Corrected roof shape and T-E support arrangement

Looking west at the east side • full existing roof outline, with T-E section dotted

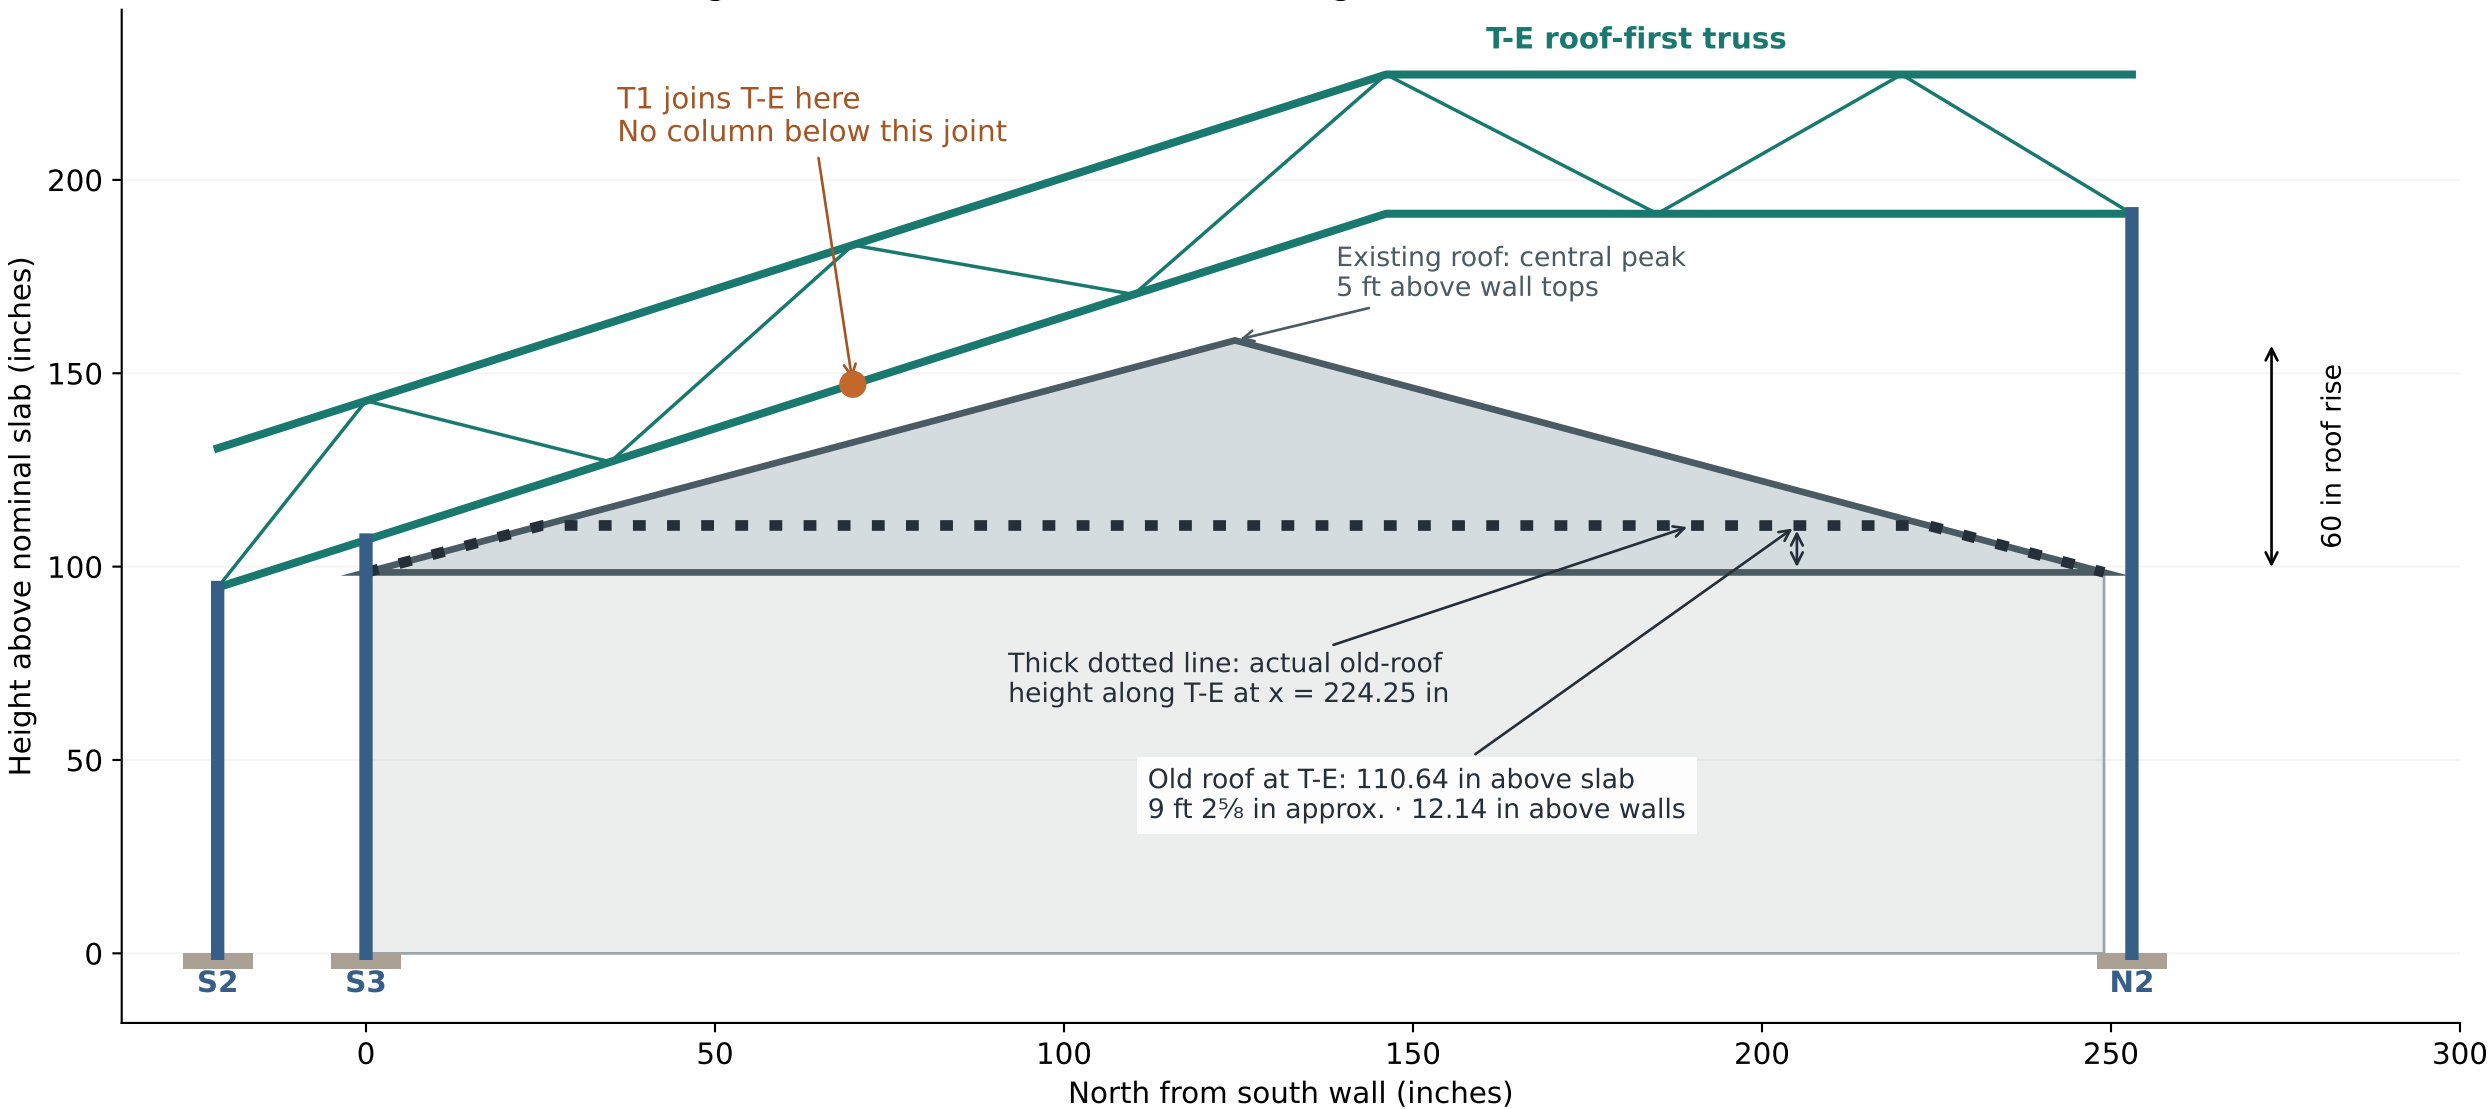
Existing roof: single-point pyramid, no ridge segment. Footprint retained at 249.5 × 249 in pending dimension reconciliation. Green truss uses the earlier 36-in envelope for illustration only; it has not been sized for T1's transferred load. Eaves remain unmeasured.
